**GROWTH MANAGEMENT DEPARTMENT STAFF REPORT**  
**SOUTH ANASTASIA OVERLAY DISTRICT**  
January 26, 2023 Public Meeting  
SADRB 2022-05 7740 A1A Offbeach Parking

**Summary of Request:** Applicant is requesting design approval for a proposed St. Johns County park with an associated parking lot and restroom facility with beach access. This review is specifically for the structures proposed for the site: the restroom facility, and the signage. The applicant has been requested to provide physical color/material samples at the hearing to assist in Board review. Staff notes that the proposed site plan meets all setback/buffering requirements for RS-2 zoning in the South Anastasia Overlay District, as well as impervious surface ratio and floor area ratio.

## EXTERIOR ELEVATIONS

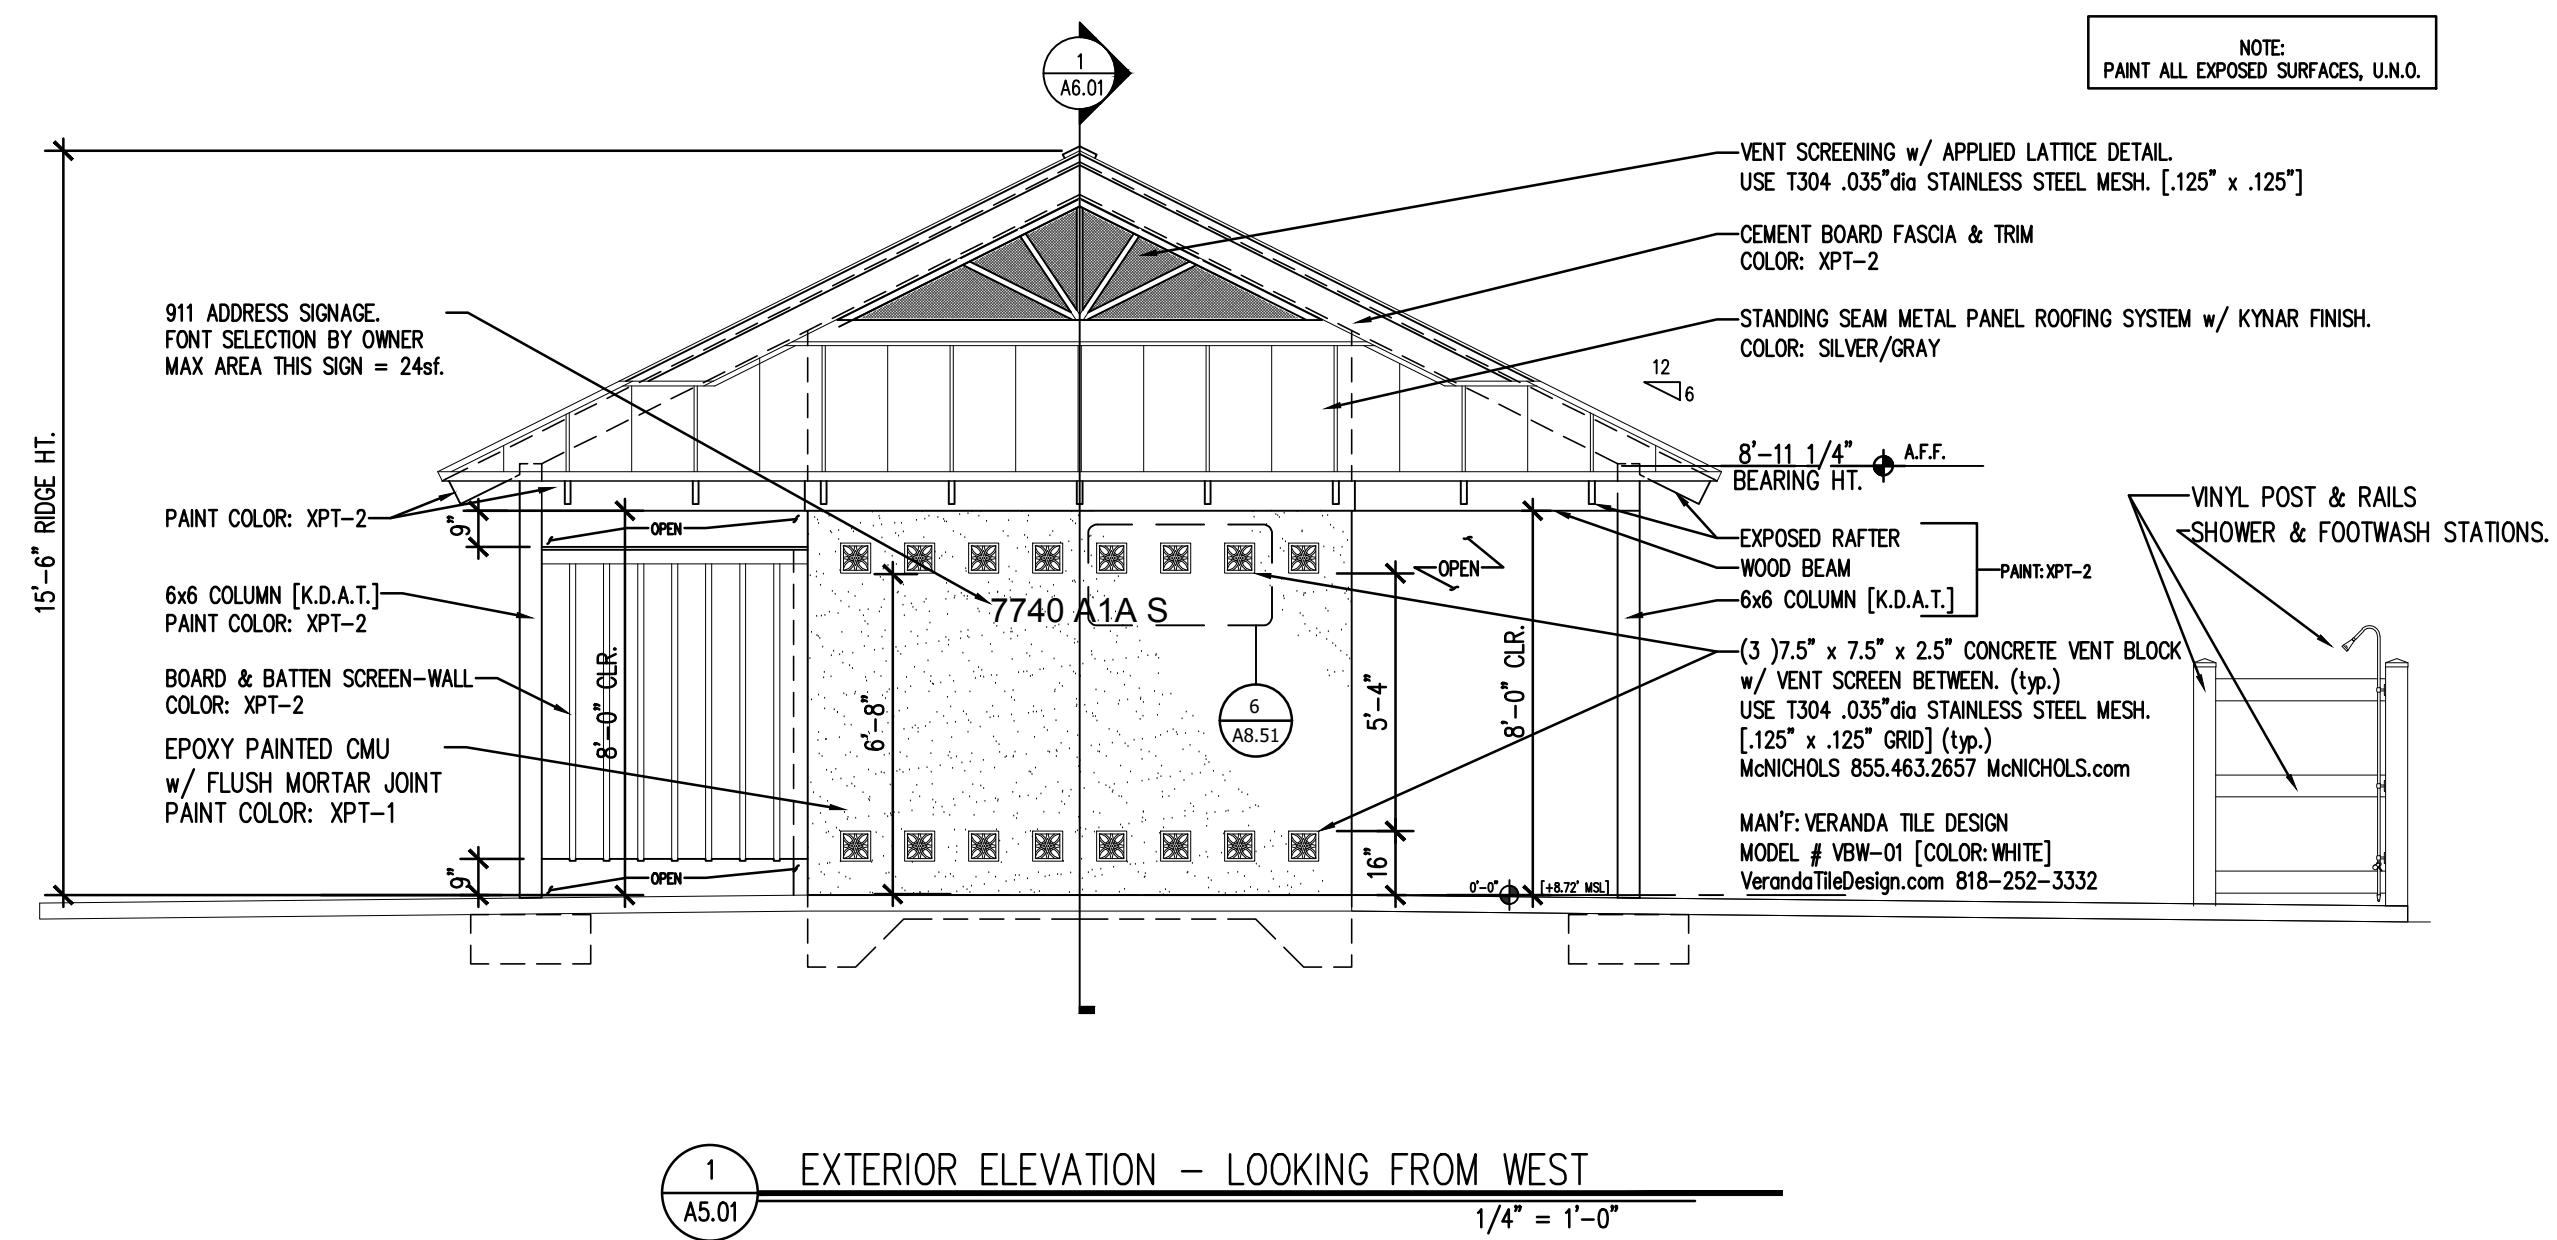
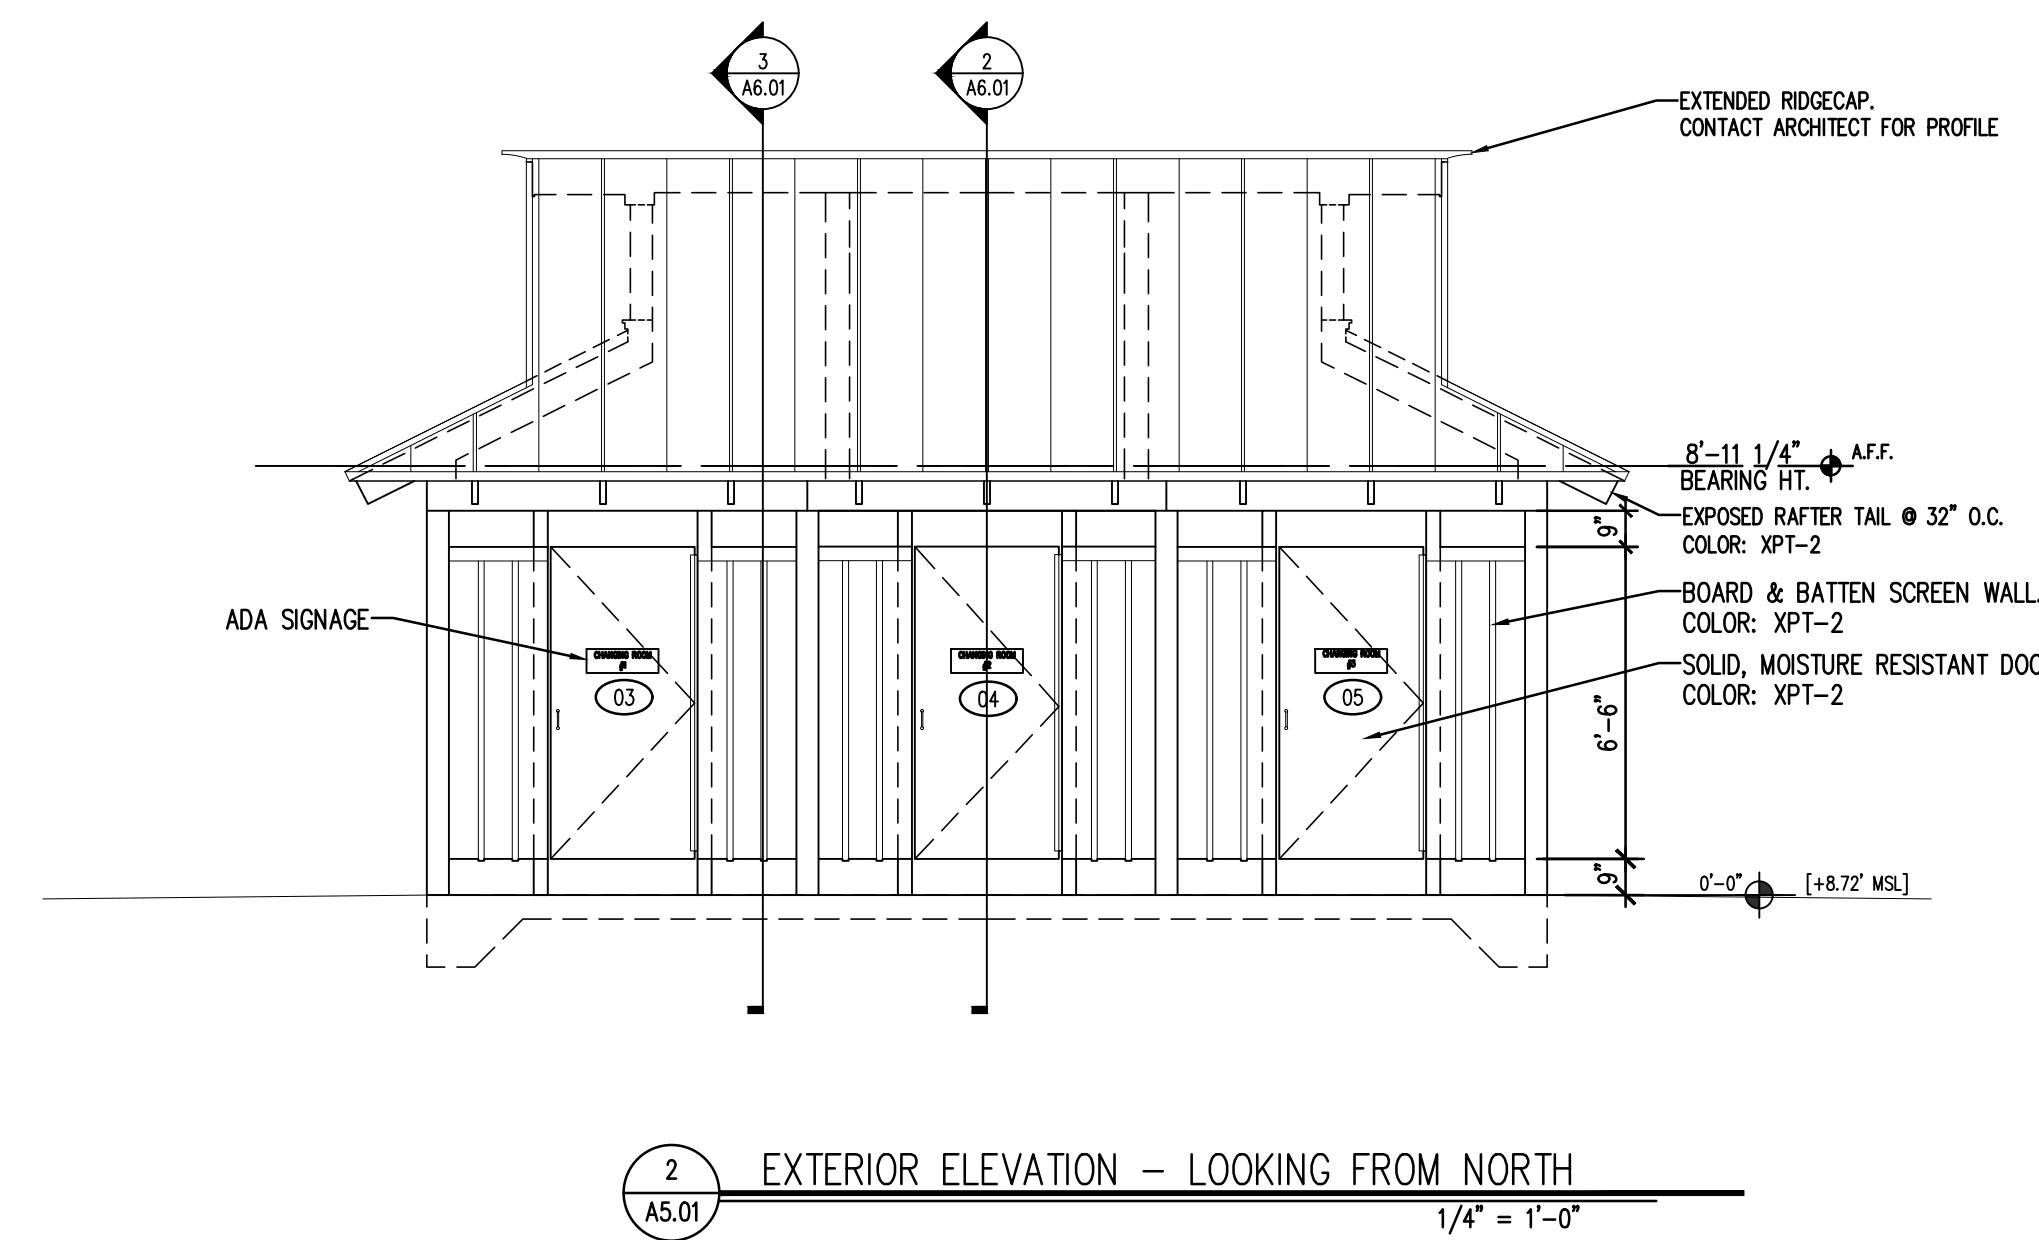
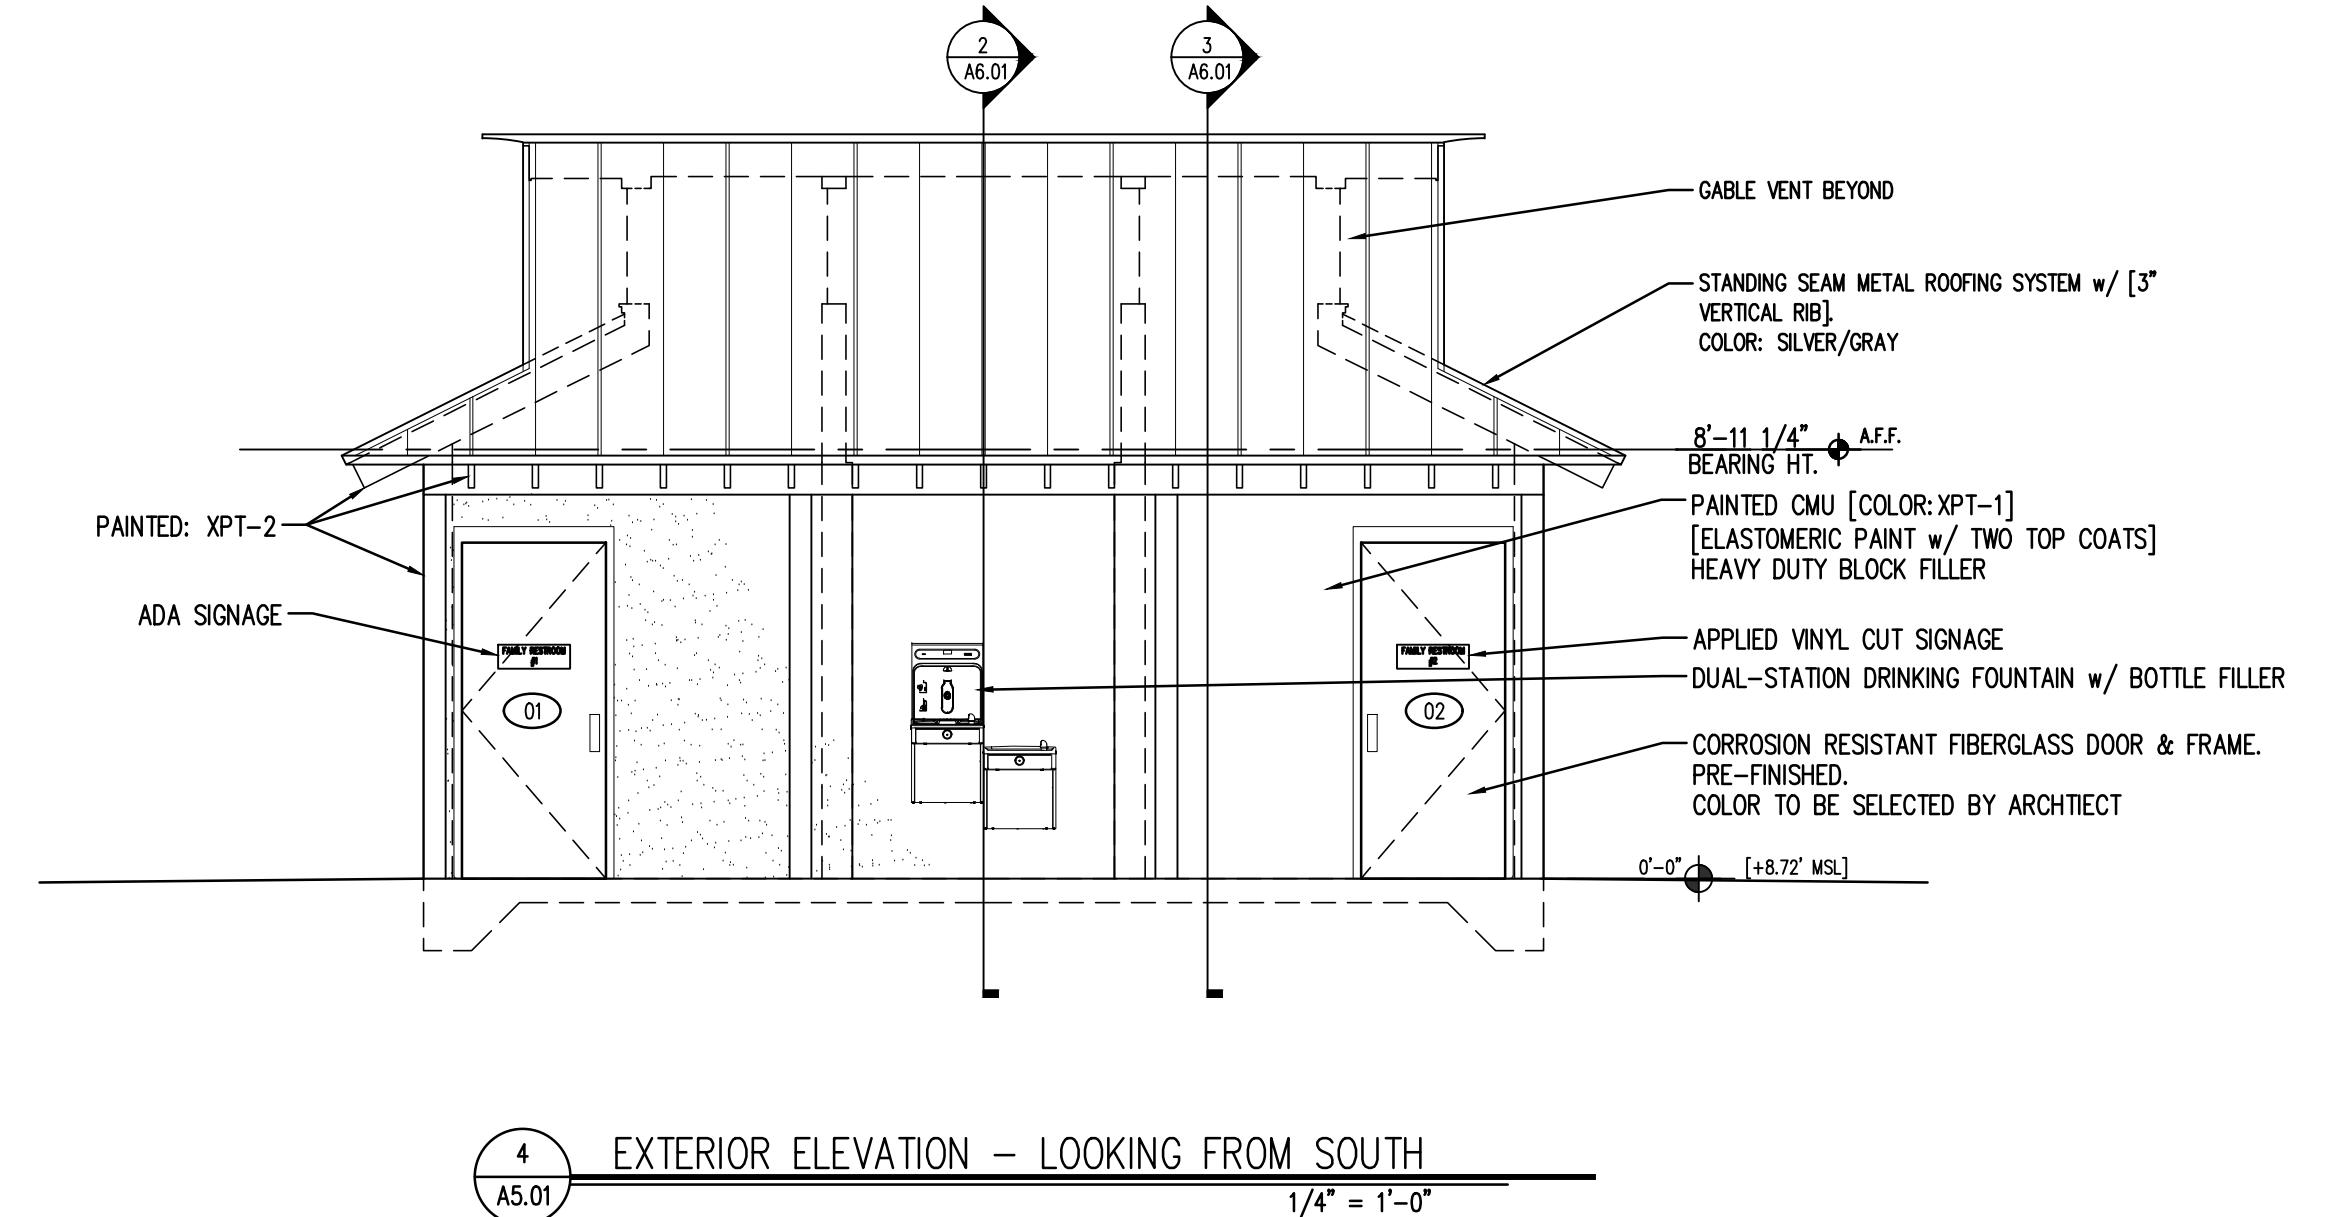
**Planning Division:** The roof design of the proposed bathroom/changing room structure appears to be consistent with LDC Section 3.07.04.A1. In regards to roof material, LDC Section 3.07.12 states, "Roof shall consist of wood or asphalt composition shingles, barrel tile, clay tile or similar non-reflective finished material having a natural texture and appearance. Metal roofs shall only be allowed where they are characteristic of a recognized architectural style." The proposed metal roof may be allowed if it is deemed characteristic of the "Old Florida" style. Additionally, the proposed color scheme appears to comply with the architectural design standards in the "Old Florida" style as set forth in LDC Section 3.07.11.
